**PRELIMINARY SOIL, GEOLOGY, GEOLOGIC HAZARD,
AND WASTEWATER STUDY,
MCCUNE RANCH SUBDIVISION
PARCEL NO. 51000-00-493
17480 MERIDIAN ROAD NORTH
EL PASO COUNTY, COLORADO**

October 2, 2018

Add "PCD File No. SP-18-006"

GEOLOGY/ENGINEERING GEOLOGY MAP
MCCUNE RANCH SUBDIVISION
 17480 MERIDIAN ROAD NORTH
 EL PASO COUNTY, CO.
 FOR: PROTERRA PROPERTIES, LLC

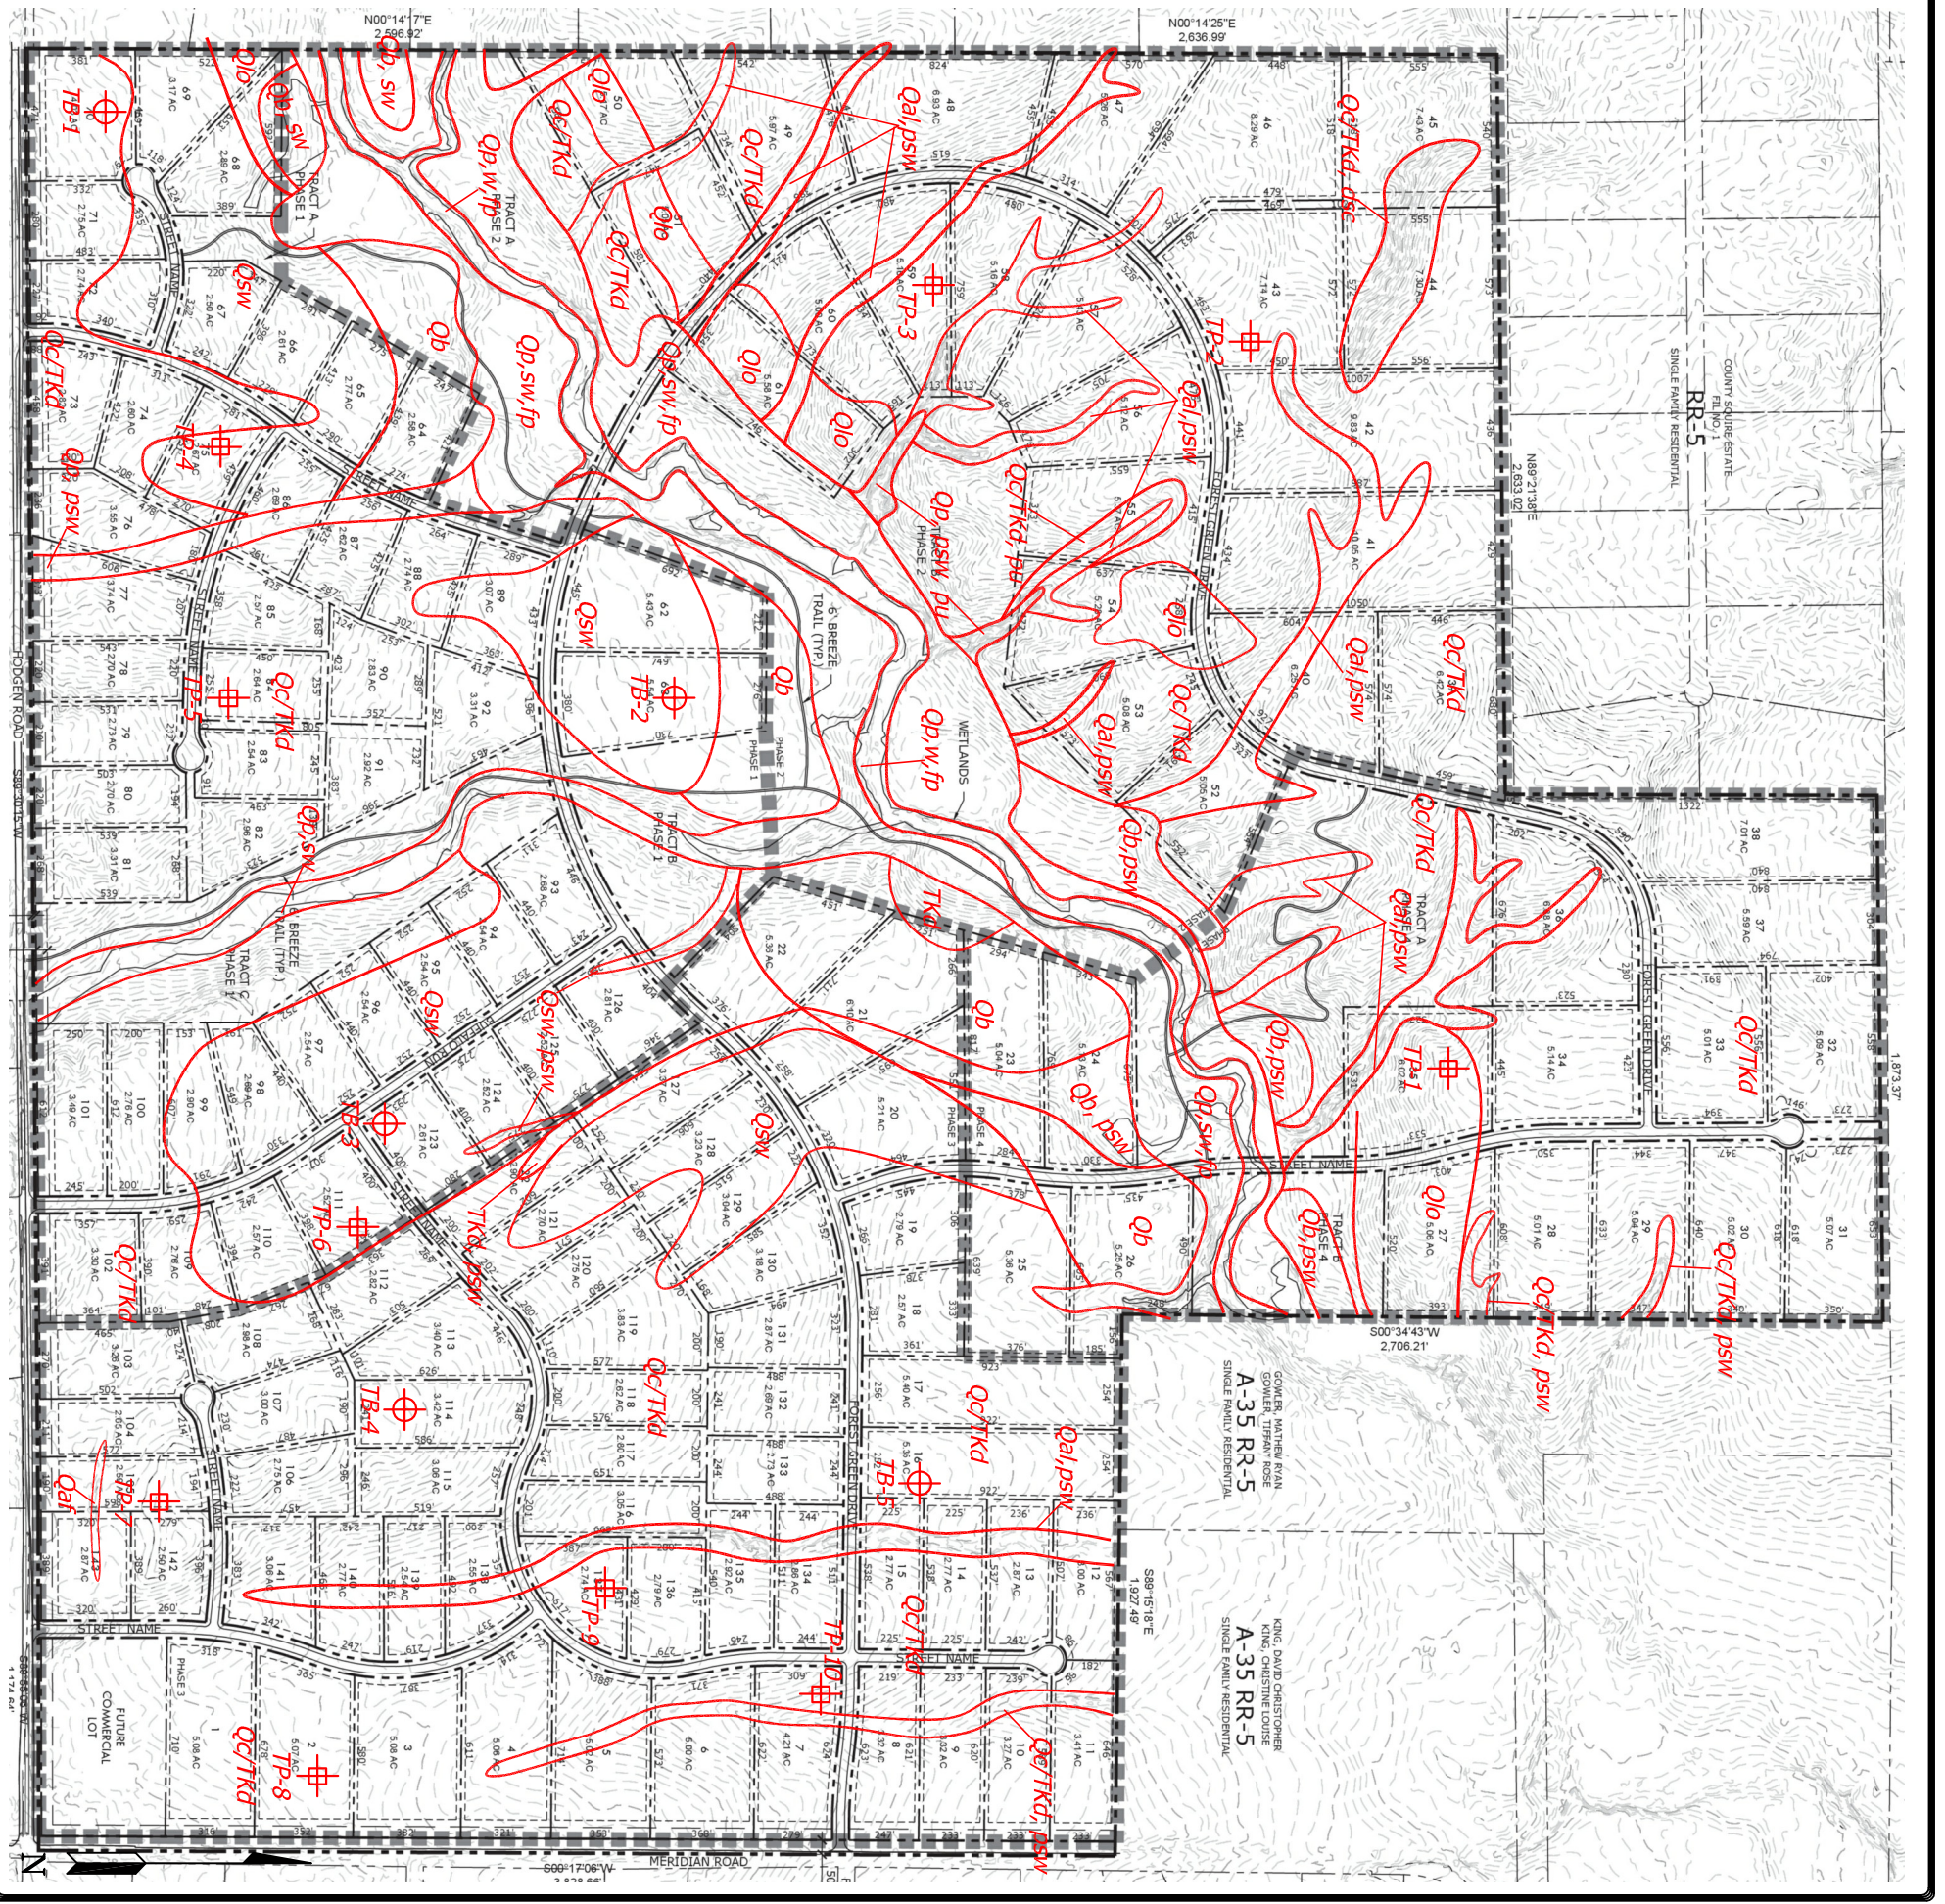
Show the hazards on the preliminary plan
